# Access Compliance Report

## Public Rights-of-Way

Intersection ID: 21955	Main Street: DELPOND_LN	Cross Street: SUTTON_SPRINGS_RD	Location:	N
ADA ID: 93CA97A5AE0B	Ramp Type: PerpDiag	Initial Pass/Fail: Fail	Overall Compliance: No	Severity Score: 10

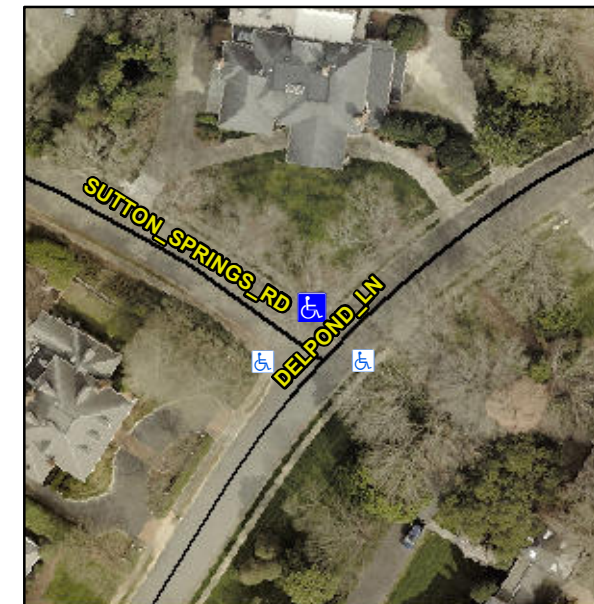
**Not Found, R304.5.1, R304.5.3**

Compliance	Description	Data	Compliance	Description	Data
N/A	Ramp Length (in)	50.5	Yes	Ramp Slope (%)	5.1
No	Ramp Width (in)	36.0	No	Ramp XSlope (%)	3.0
N/A	Flare Type LT	N/A	N/A	Flare Type RT	N/A
N/A	Flare Slope LT (%)	N/A	N/A	Flare Slope RT (%)	N/A
N/A	Flare Traversable LT?	N/A	N/A	Flare Traversable RT?	N/A
N/A	Landing Length (in)	N/A	N/A	DWS Provided?	N/A
N/A	Landing Width (in)	N/A	N/A	DWS Contrast?	N/A
N/A	Landing Slope (%)	N/A	N/A	DWS Length (in)	N/A
N/A	Landing X Slope (%)	N/A	N/A	DWS Full Width?	N/A
N/A	Landing Curb? (Y/N)	N/A	N/A	DWS Offset (in)	N/A
N/A	Shared Landing?	N/A			
N/A	Gutter Ponding?	N/A	N/A	Gutter Slope (%)	N/A
N/A	Gutter Lip Ht (in)	N/A	N/A	Gutter X Slope (%)	N/A
N/A	Painted X Walk1?	No	N/A	Painted X Walk2?	No
	X Walk 1 Direction	To SW		X Walk 2 Direction	To SE
N/A	X Walk 1 Width (in)	N/A	N/A	X Walk 2 Width (in)	N/A
	X Walk 1 Slope (%)	6.2		X Walk 2 Slope (%)	2.3
	X Walk 1 X Slope (%)	4.3		X Walk 2 X Slope (%)	5.8

**Remove & Replace Curb Ramp With Two New Directional Ramps or Equivalent.**
